2. 210779 Resolution relating to a Certificate of Appropriateness for chimney reconstruction, and dormer re-cladding at 2640 N. Lake Drive, in North Point North Historic District, for Russell and Dorothy Case.

**RE: Resolution relating to a Certificate of Appropriateness for chimney reconstruction, and dormer re-cladding at 2640 N. Lake Drive, in North Point North Historic District, for Russell and Dorothy Case.**

Your application listed above was heard at the Historic Preservation Commission meeting of January 10, 2022. At this meeting, the Commission denied your application for the chimney tuck pointing and use of Smartside on the dormer.

# CHIMNEY

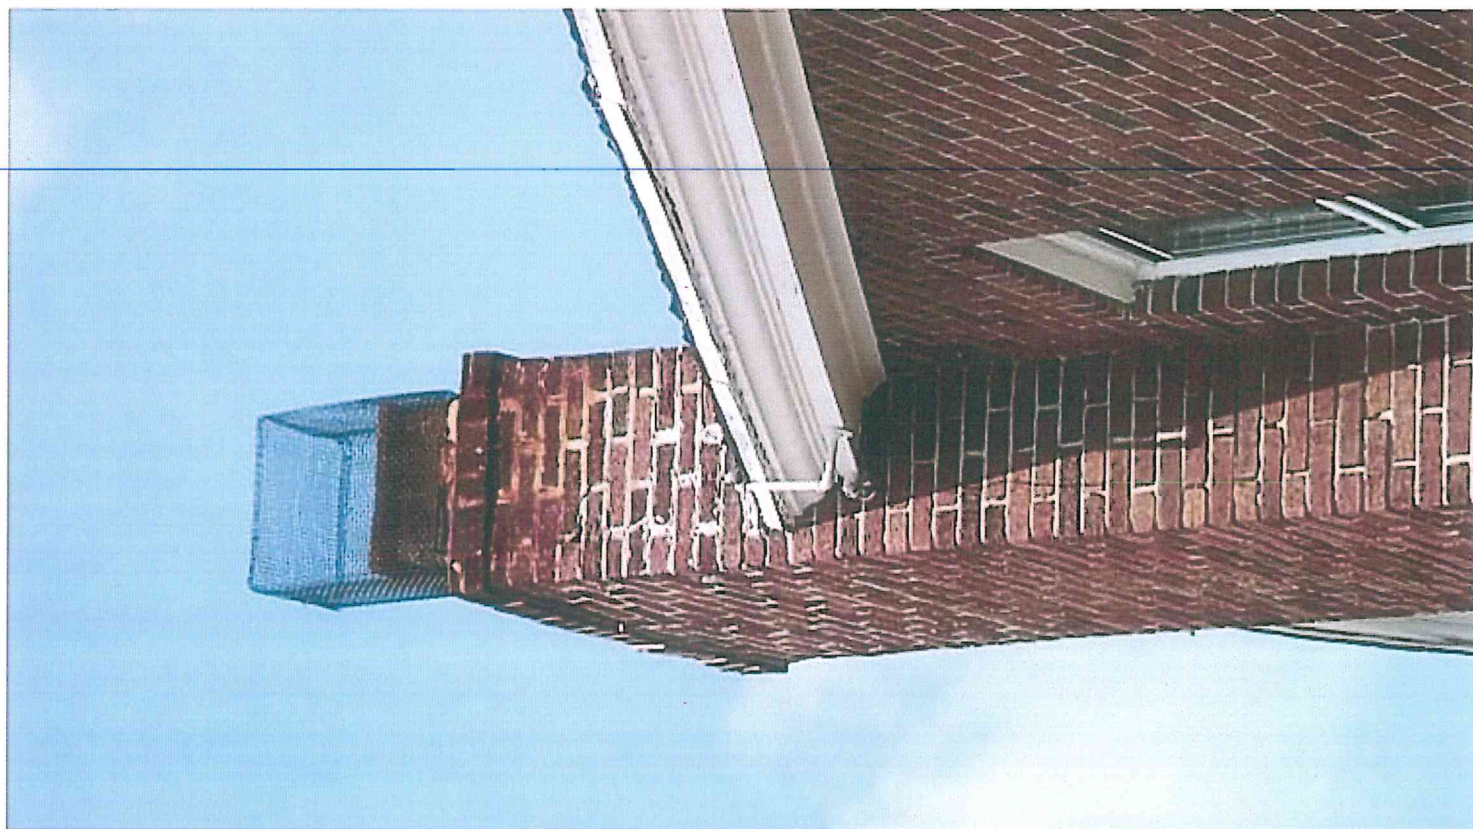
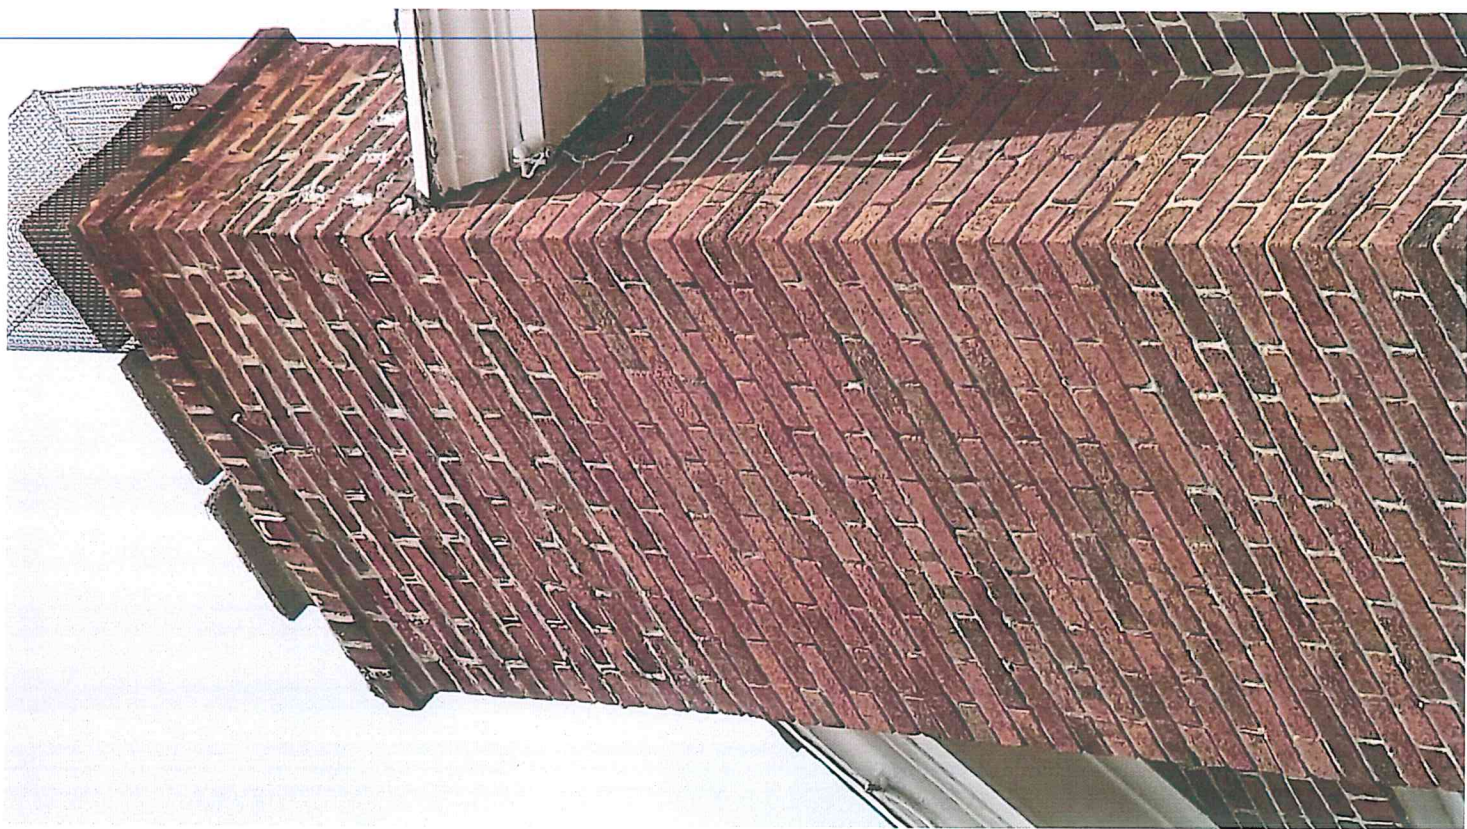
1. How were the dormers re-clad? It went from shingles to Tyvek.
2. The chimney flashing is not ideal. What was done here? If it wasn't significantly altered and primarily just re-tarred, there shouldn't be a problem. If the flashing up the side of the chimney was entirely redone with new metal, I really shouldn't approve it and it will not be approved for the tax credit.

The language regarding chimney flashing is assigned condition #4 of your Wisconsin Historical Society approval. The article you sent shows exactly the technique that is prohibited. It is not a best practice. Further, the chimney was not rebuilt above the roof line to match existing conditions in joint style, width, or quality.

1. Remove chimney cap
2. Tear down chimney to roof line
3. Rebuild with proper joints
4. Pour new chimney cap with 1 1/4" overhang
5. Cut in copper flashing
6. Clean up all job related debris
7. All material supplied by JA Homeworx LLC
8. Lifetime warranty by JA Homeworx LLC workmanship

DORMER

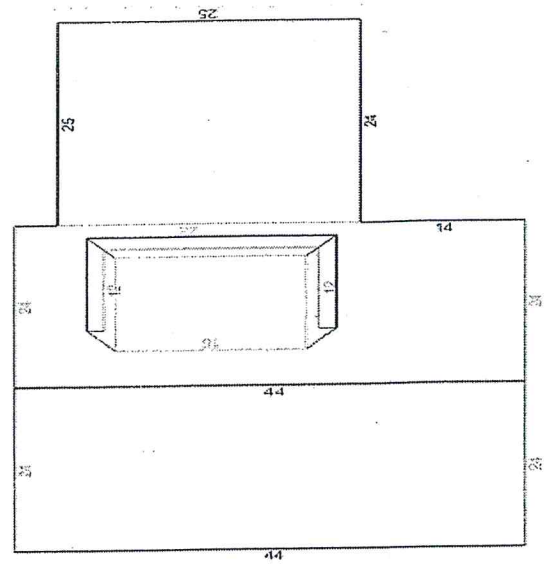
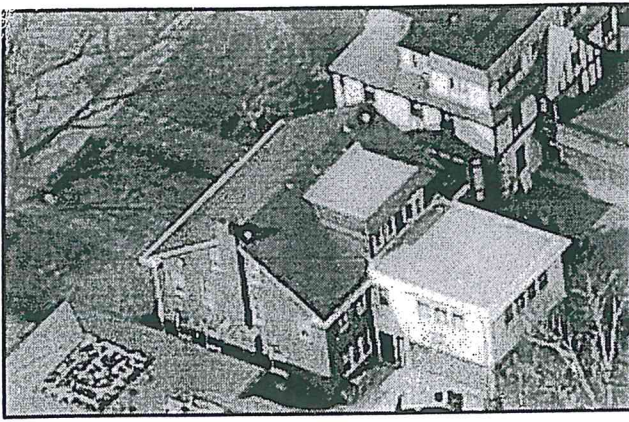
Further, the siding does not appear to be wood. This will have to go before the Commission on October 11.

1. Remove LP smart side and corners on upper dormer of house
2. Install #1 Cedar lap siding and corner boards to match lap siding on lower of house
3. Seal, Prime, and paint
4. Clean up all job related debris
5. All material supplied by JA Homeworx LLC
6. Lifetime warranty by JA Homeworx LLC workmanship
